NEW ELEMENTARY SCHOOL  
9801 HIGHLAND KNOLLS DR  
BAKERSFIELD  
CALIFORNIA  
93306

NEW MIDDLE SCHOOL  
4115 VINELAND ROAD  
BAKERSFIELD  
CALIFORNIA  
93306

JOB NUMBER:  
20101244  
CAD DRAWING FILE:  
DRAWN BY:  
AC  
CHECKED BY:  
PH  
CHECK AND VERIFY ALL DIMENSIONS BEFORE  
PROCEEDING WITH THE WORK.  
REPORT DISCREPANCIES TO THE ARCHITECT.  
THE DRAWINGS, IDEAS, AND DESIGNS  
REPRESENTED ON THIS SHEET ARE THE  
PROPERTY OF THE ARCHITECT.  
COPYRIGHT  
ORDIZ MELBY ARCHITECTS, INC. 2010  
SHEET TITLE  
**LIGHTING PLAN  
BUILDING G**

SHEET IDENTIFICATION NUMBER  
**E-132G**  
SHEET OF

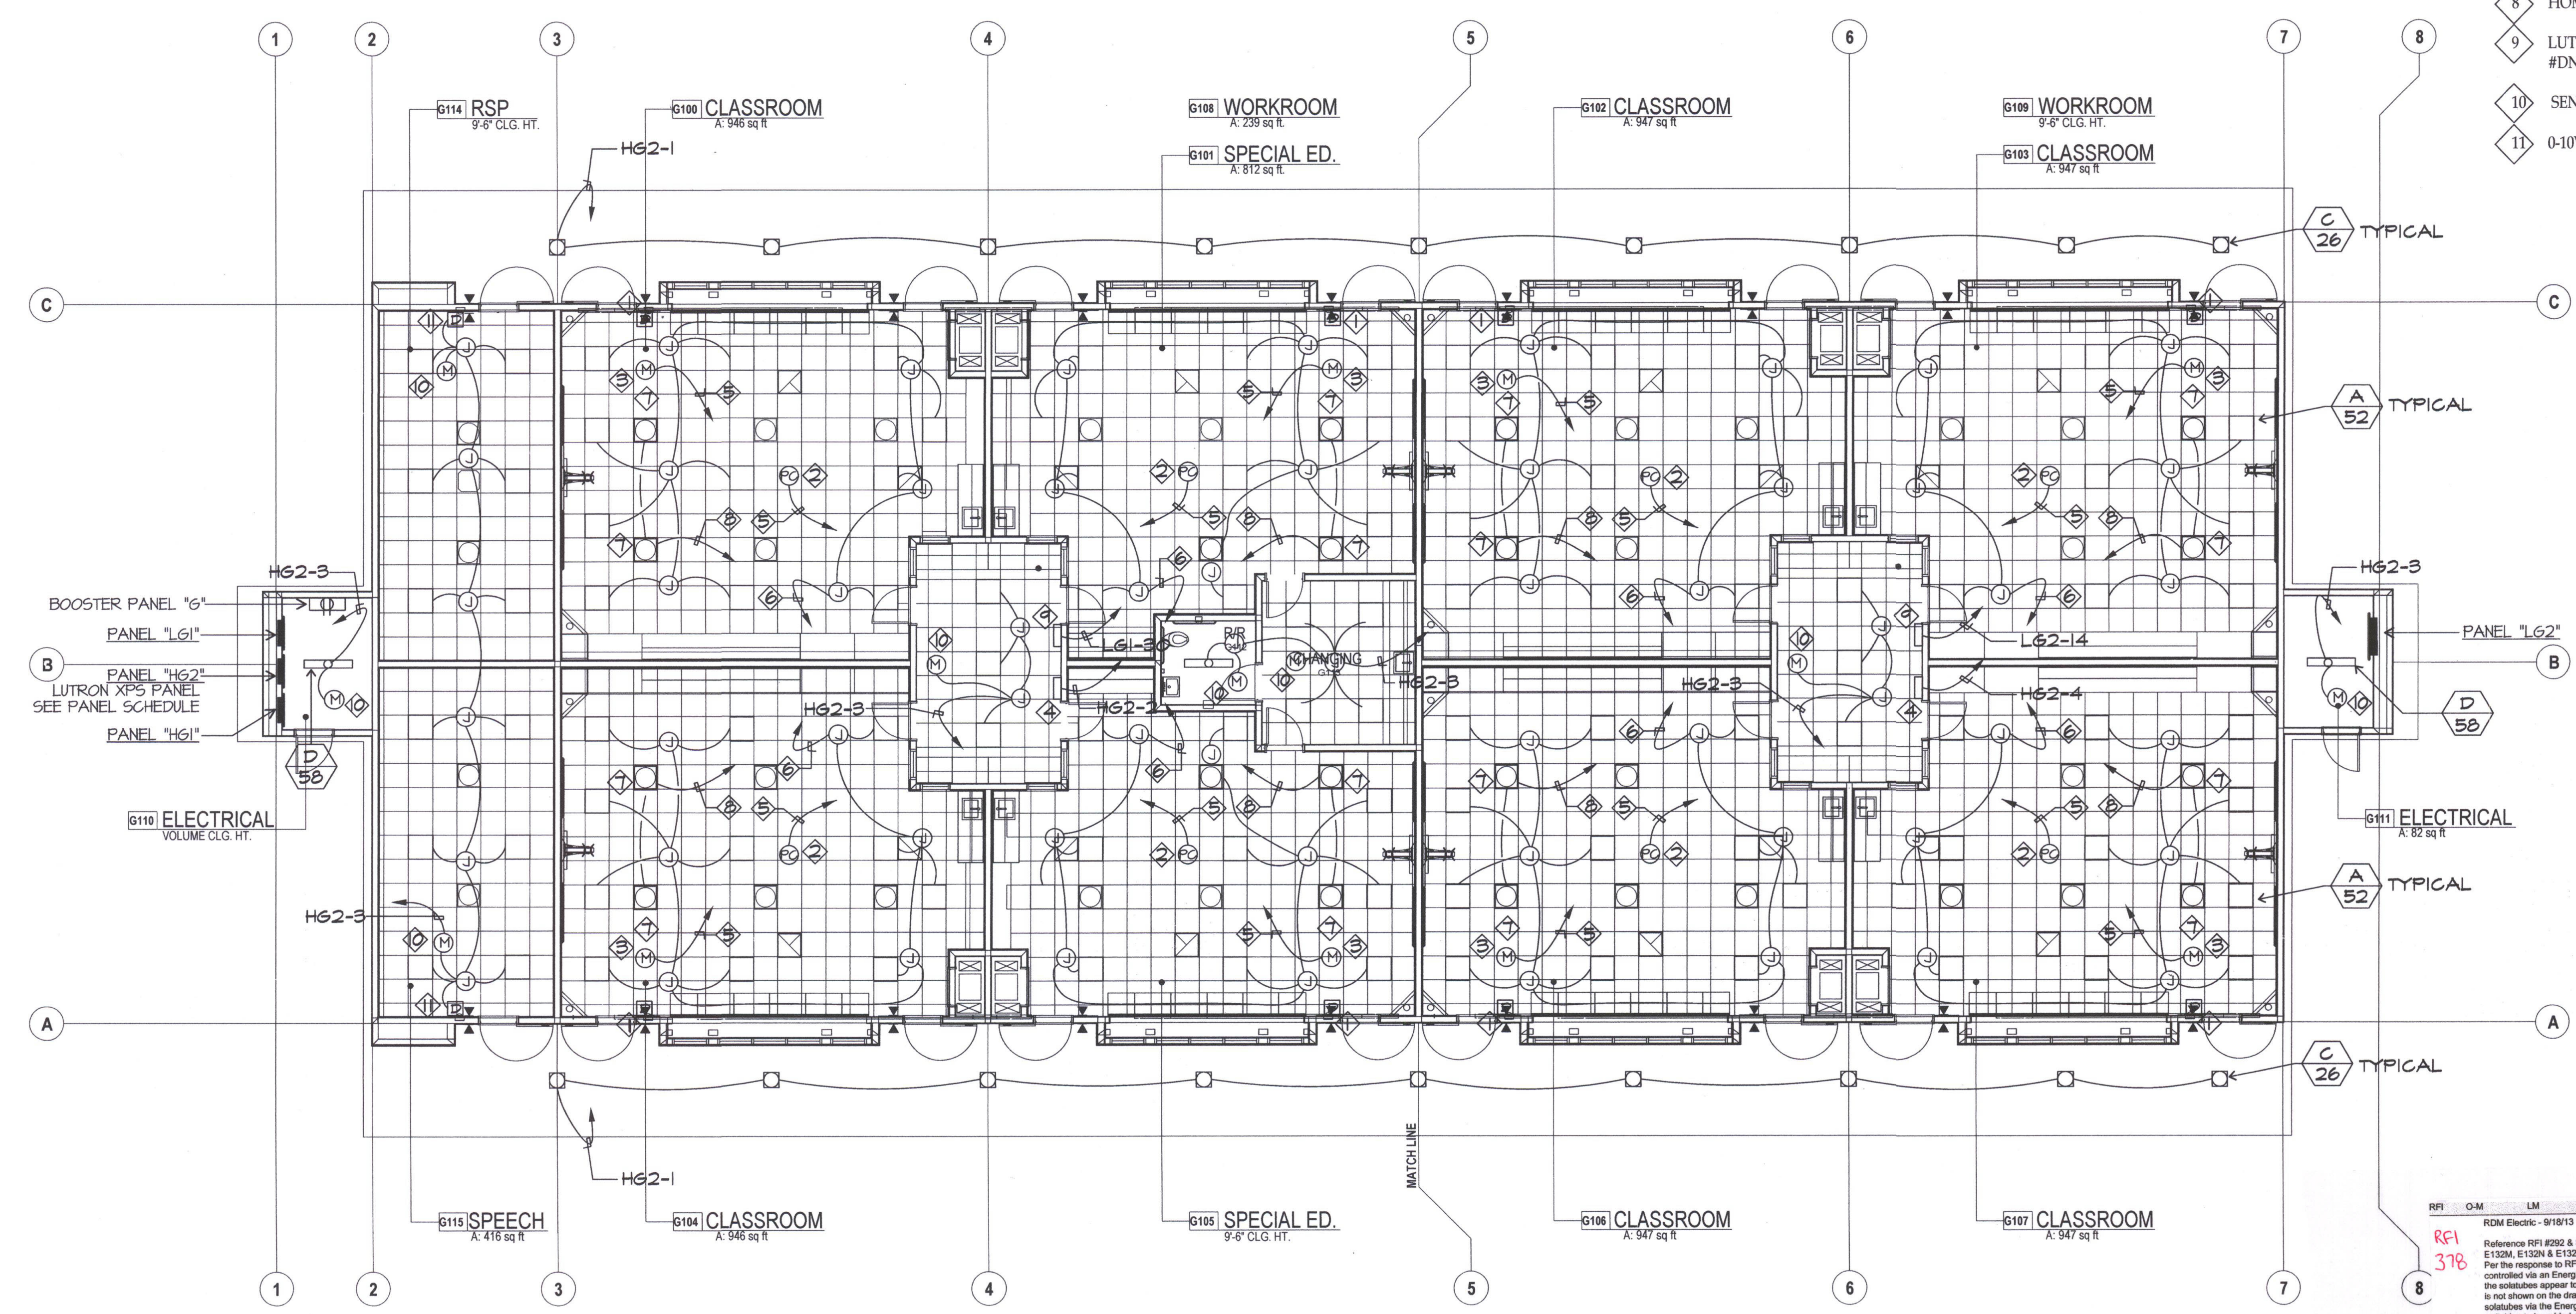
Request:  
RDM Electric - 10/9/12  
Reference Sheets E-100, E-132C, E-132D, E-132E, E-132F, E-132G, E-132H, E-132I, E-132J, E-132K, E-132L, E-132M, E-132N, E-132P & Lighting Submittal  
The General Notes on the Electrical Plans show the lighting dimmers to be installed for the lighting at 44" to top of box and the light switches to be installed at 42". A 5-Button Lutron wall station is shown to be installed for the lighting controls in the classrooms. Please provide mounting height (levation) for the classroom lighting control wall stations.

Totomark Builders - 9/17/13  
Reflected Ceiling Plans at Buildings D & G Classrooms do not show the same Skylight Control quantities as that which are shown on Electrical Drawings Sheet E-131D and E-130J. Our Submittal submission was based on the design details shown on the Reflected Ceiling Plans. Please advise.

RFI 378  
RDM Electric - 9/18/13  
Reference RFI #202 & Sheets E-132C, E-132D, E-132E, E-132F, E-132G, E-132H, E-132I & E-132P  
Per the response to RFI #202, the submittals in the classrooms are to be controlled via an Energi Savr Node. However, per the attached cut sheets, the submittals appear to need separate DC switching to be controlled, which is not shown on the drawings. The plans only show to supply 120V from the submittals via the Energi Savr Nodes. Do the classrooms have DC switching to be added as a means of controlling the submittals? If so, please advise on the requirements.  
Contact closure on Energi Savr Node will operate submittal shutter. We verified this with Totomark and Lutron.  
John Moberly - JMPE - 9/19/13

Answer:  
Joseph W. Covington - Ordiz Melby (10/11/12)  
Install all switches and dimmers at 42" to the center of the box.

Joe Covington - OMA - 9/17/13  
After review of Architectural Plans it has been determined that the Building D and G refer to one Classroom in Building D100 as "TYPICAL MIDDLE SCHOOL" classroom.  
The Reflected ceiling plan for this one classroom indicates the dimmer provided for the skylights as required for the "TYPICAL MIDDLE SCHOOL" classroom.  
Whether or not they are shown on other reflected ceiling plans should have raised the question prior to bid.  
The fact that the Electrical documents indicate the required electrical connections to be provided for all the locations considered TYPICAL should also have raised the question concerning which skylights are provided with dimmers shown all documents are to be reviewed and coordinated prior to bid.  
Elementary and Middle rooms were designed with the same exact same layout and amenities, and no statements providing direction of EXCEPTIONS was provided for this use.
